# PERMIT

SEWAGE DISPOSAL SYSTEM  
MARYLAND STATE DEPARTMENT OF HEALTH

SUBDIVISION Clarkville Ridge ROAD 11509 Crows Nest Road LOT

PROPERTY OWNER Mr. Allen Ewing ~~11509~~ Mr. and Mrs. Soren Harbom

HOUSE LOCATION *J. E. Nadeau*  
LOT 39

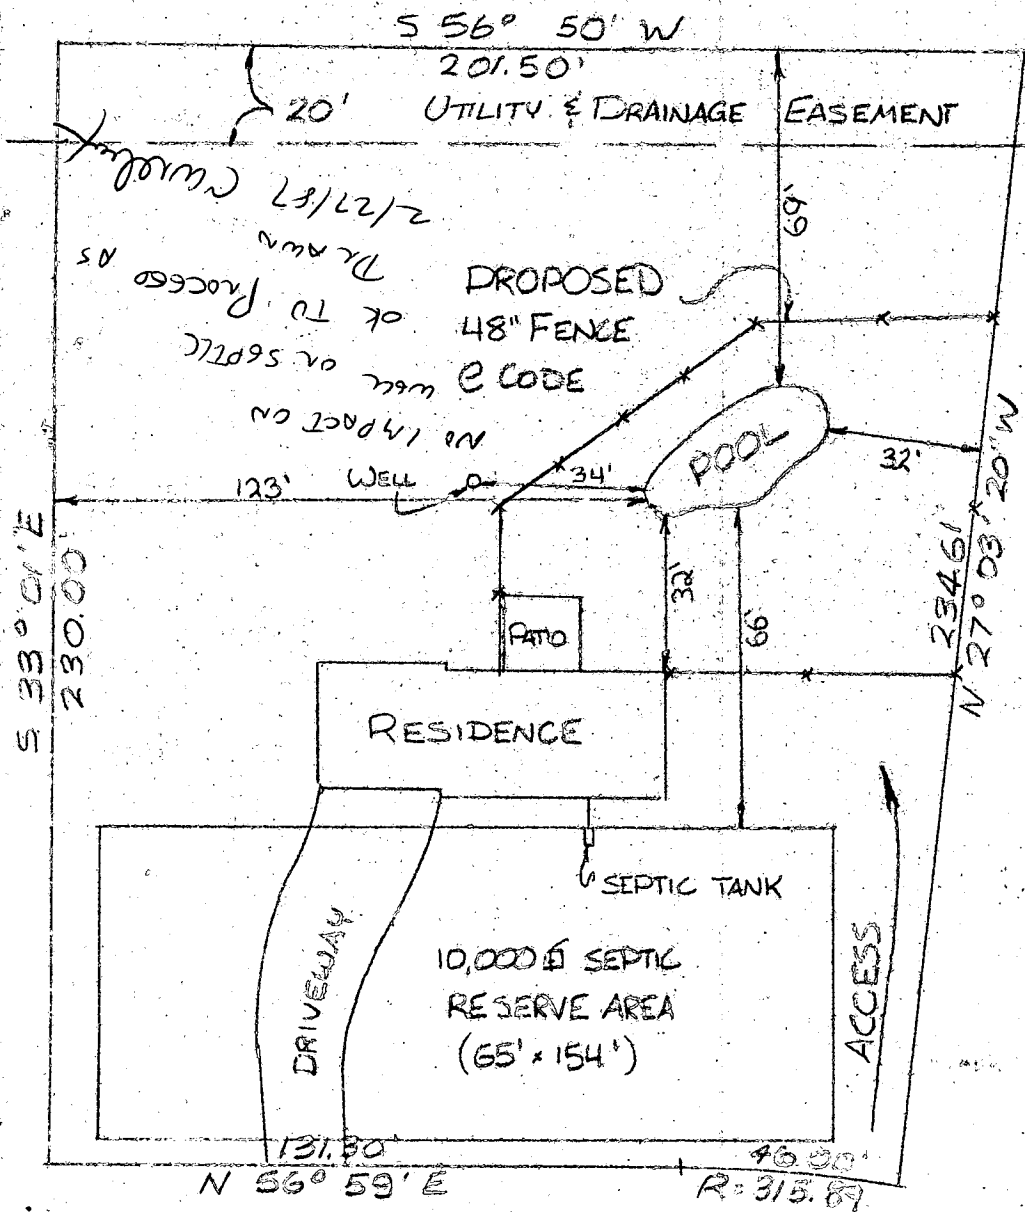
12-21-87  
Septic system is traceable by visual inspection, probably at capacity. Septic tank was within 1 foot of top. Green heavy grass growth indicated trench locations. Well is 26 ft downhill from existing patio, would be just 30 ft from addition. Recommend addition to septic trenches to handle additional water usage in addition kitchen.

CONTRACTOR INSPI. WITHIN PAST 6 MOS. HE BELIEVES GREEN GRASS WAS NOT IN PLACE SETTING FINDINGS INCONCLUSIVE, NO OVERFLOW.
